CERTIFICATE OF APPROPRIATENESS

Applicant: Alexander Ridgeway, Brickmoon Design for Todd and Denise Liebl, owner

Property: 501 Highland Street, lot 16, block 9, Woodland Heights Subdivision. The property includes a historic 1,654 square foot two story residence and two story garage-apartment situated on a 5,000 square foot (50' x 100') corner lot.

Proposal: Alteration – Addition

SOUTH ELEVATION – FRONT FACING HIGHLAND STREET

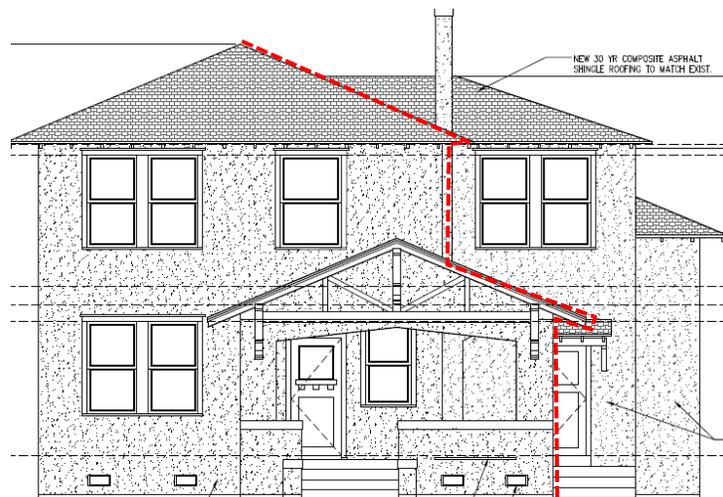
Front Elevation: Lift the existing residence 11" and install 4 front facing crawlspace vents. Replace all of the existing stucco with new stucco of matching texture and finish. The front existing concrete steps with three risers will be replaced with new concrete steps with 4 risers to compensate for the added height. The addition will extend 12' wider than the existing original residence and will feature a craftsman style door.

- **Inset the addition 1' from the existing structure along the east elevation. This would reduce the visibility of the addition from the street, visually delineate it from the existing residence, and comply with applicable deed restrictions. There is space at the northwest corner of the lot that could accommodate the space lost from inseting the addition along the east side.**
- **Leave the existing residence at its existing finished floor height. This would eliminate the need to modify or remove elements of the structure that are not easily moved, including the chimney and the front porch.**

EAST SIDE ELEVATION FACING HELEN STREET

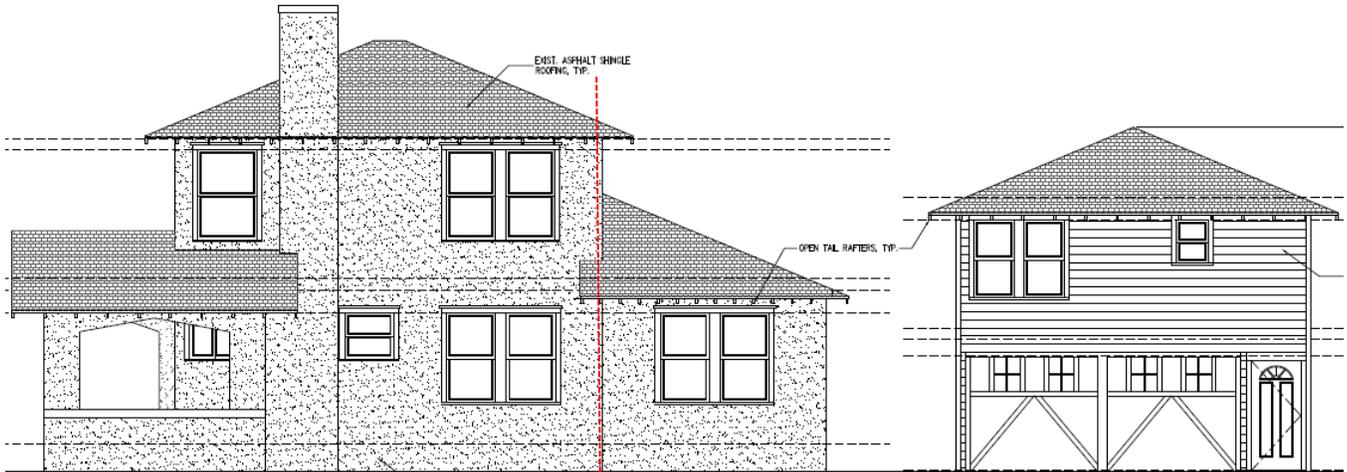
<i>The addition extends 12' closer to the street than the existing original house while connecting to the garage apartment. This undermines the character of the relatively narrow existing residence by creating a mass that is significantly wider than the existing residence. This is compounded by the fact that the addition attaches a reconstructed rear two-story garage resulting in a mass that gains width towards the rear of the property.</i></p> |

Side Elevation: Lift the existing residence 11" and install 7 crawlspace vents. Replace all of the existing stucco with new stucco of matching texture and finish. The addition will begin at the rear wall of the original structure or 25' 11" from the front wall of the existing structure. This will necessitate removing an existing one story non-original rear addition. The addition will feature two windows on the first floor and three on the second. The addition will extend 21' 5" towards the rear of the property and connect with the existing side facing garage-apartment. The garage's existing 105 cladding will be removed and replaced with stucco matching the residence and the addition. The garage will feature new wood garage doors on the first floor a pair of windows on the second and a juliet balcony.

WEST SIDE ELEVATION

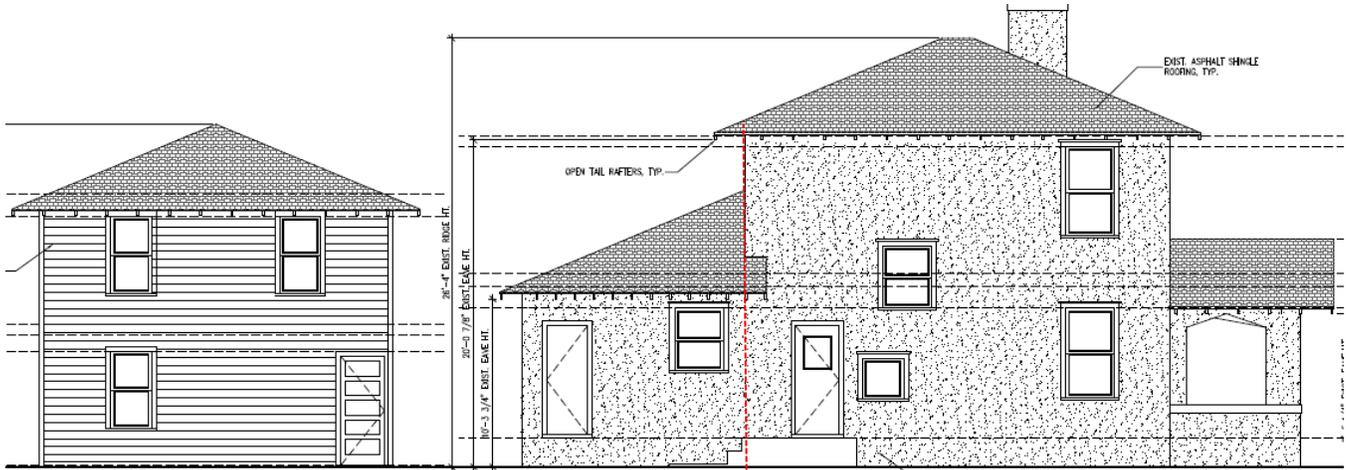
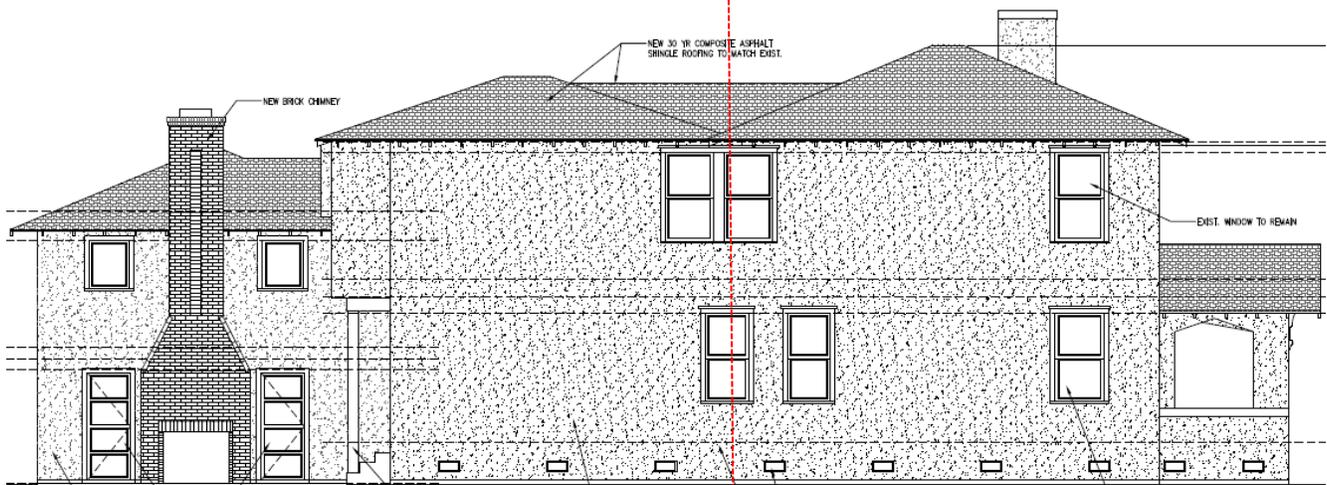
Windows/Doors: The existing residence features historic double hung wood 1-over-1 windows. The applicant proposes to retain most of these windows and install matching windows in the addition. The applicant proposes the following fenestration changes along the west elevation: Remove a smaller vent window on the first floor, a 1-over-1 window between the first and second floor, and a side door. The two windows will be replaced with stucco cladding and the side door will be replaced with a new double hung wood window. The modified framing within the interior of the structure shows that the vent window and side door are not original to the structure.

Side Elevation: Lift the existing residence 11" and install 7 crawlspace vents. Replace all of the existing stucco with new stucco of matching texture and finish. Remove an existing single lite window next to the existing side door and a 1-over-1 window between the first and second floors. These openings will be covered with stucco cladding. Remove the existing non-original side door and replace with a new window. The addition will extend 21' 7" towards the rear of the property.

NORTH (REAR) ELEVATION

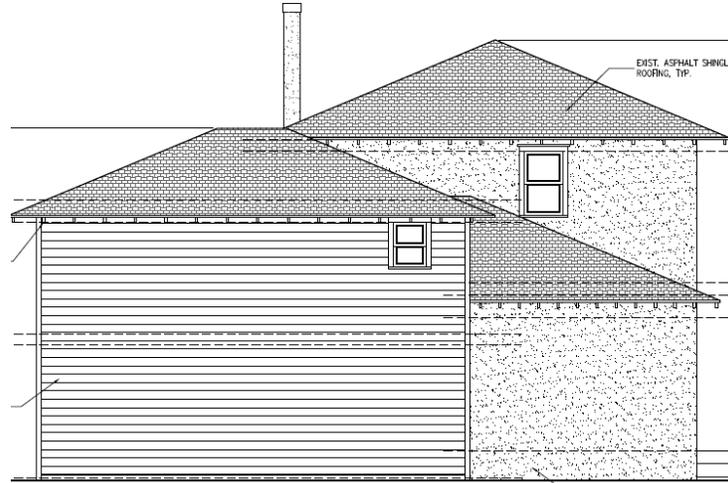
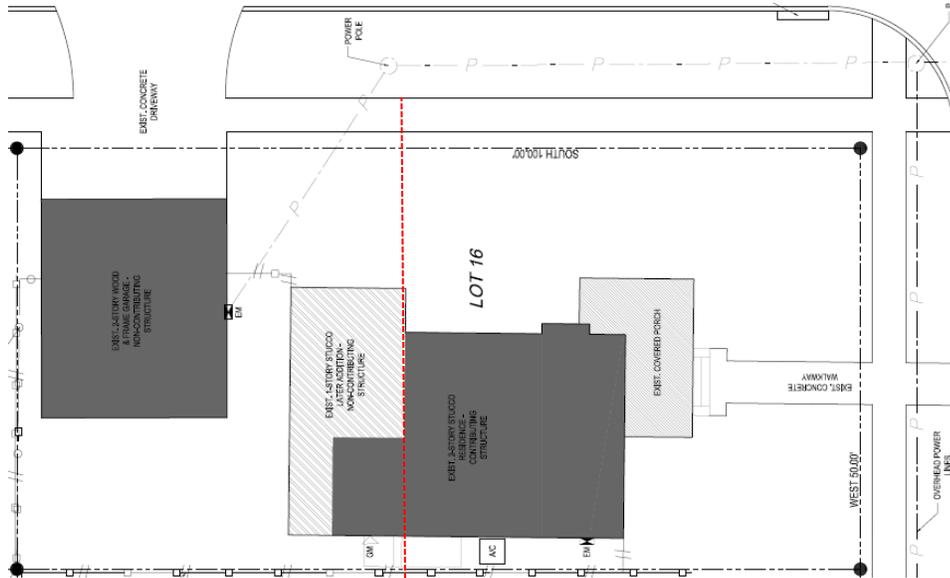
Rear Elevation: Remove the existing 105 siding from the existing garage-apartment and replace with stucco. Install a north facing shed roofed pop up in the existing hipped roof structure.

EXISTING PHOTO SHOWING SHIPLAP REMOVED WITHOUT A PERMIT

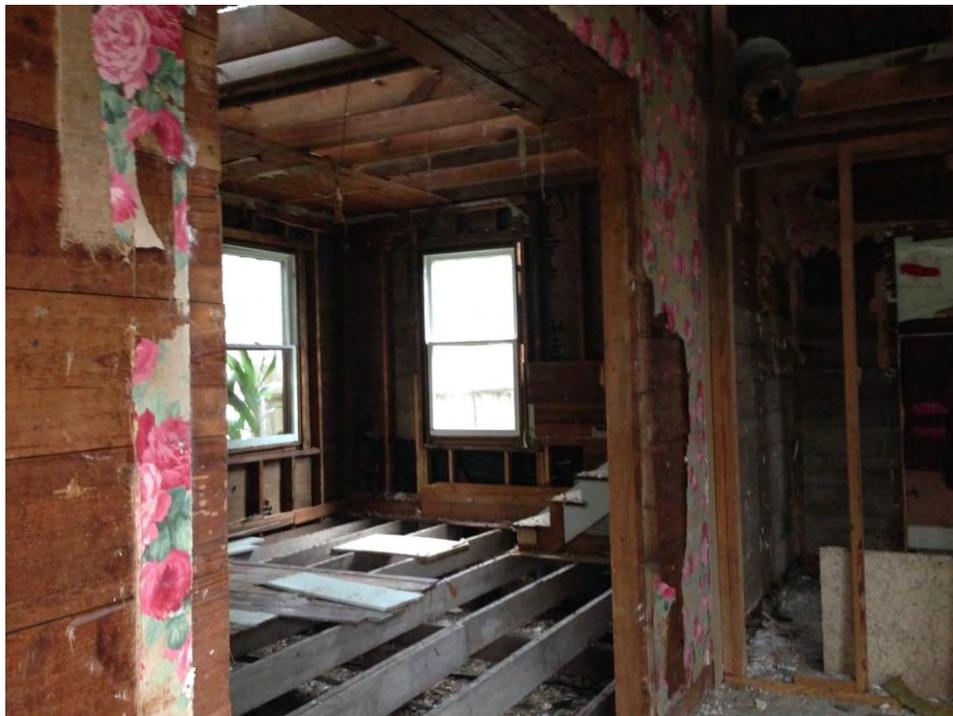
- Remove the existing residence's structural wall material. During a site visit, staff noted that the applicant had exceeded a permit to remove interior finishes by removing all of the historic shiplap. The applicant asserts that the removal of the shiplap was not intended and was the result of the demolition crew exceeding their instructions.

<i>The proposed lifting of the residence risks damaging or significantly altering the existing front porch and chimney. These features need to be rebuilt as part of a structure being raised. The house's original structural shiplap has been removed and destroyed.</i></p> |

All materials in exterior walls, including windows, siding, framing lumber, and interior shiplap must be retained except where removal or replacement has been explicitly approved by HAHC. Shiplap is an integral structural component of the exterior wall assembly in balloon framed structures and its removal can cause torqueing, twisting and collapse of exterior walls. Shiplap may be carefully shored and removed in small portions to insulate, run wire or plumbing, and should be replaced when the work is complete. Maintenance and minor in-kind repairs of exterior materials may be undertaken without HAHC approval, but if extensive damage of any exterior wall element is encountered during construction, contact staff before removing or replacing the materials. A revised COA may be required.

EAST FACING SETBACK

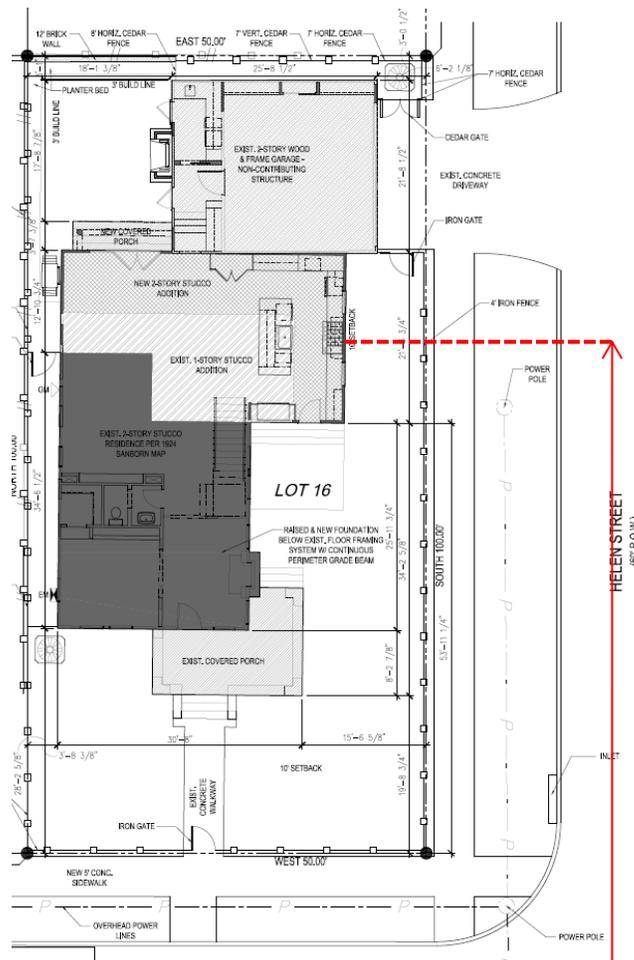
- (10) The setback of any proposed construction or alteration must be compatible with existing setbacks along the blockface and facing blockface(s);
- (11) The proposed activity will comply with any applicable deed restrictions.
The section II number 2 of Declaration of Restrictions for Woodland Heights mandates that all new structures must be set back 10' from a property line abutting a public street, or 45' from the center of the street, whichever is greater. The proposed addition will be set back 10' from the Helen Street (east) facing property line but is set back only 40' from the center of the street. This proposed setback violates Woodland Heights' deed restrictions. The violation has been confirmed by the Woodland Heights Neighborhood Association and the City of Houston Legal Department.

Existing residence set back 46.6' from the center of the street. 16.6' from the east property line which is 30' from the center of the street.

Proposed addition new set back 40' from the center of the street. 10' from the east property line which is 30' from the center of the street.
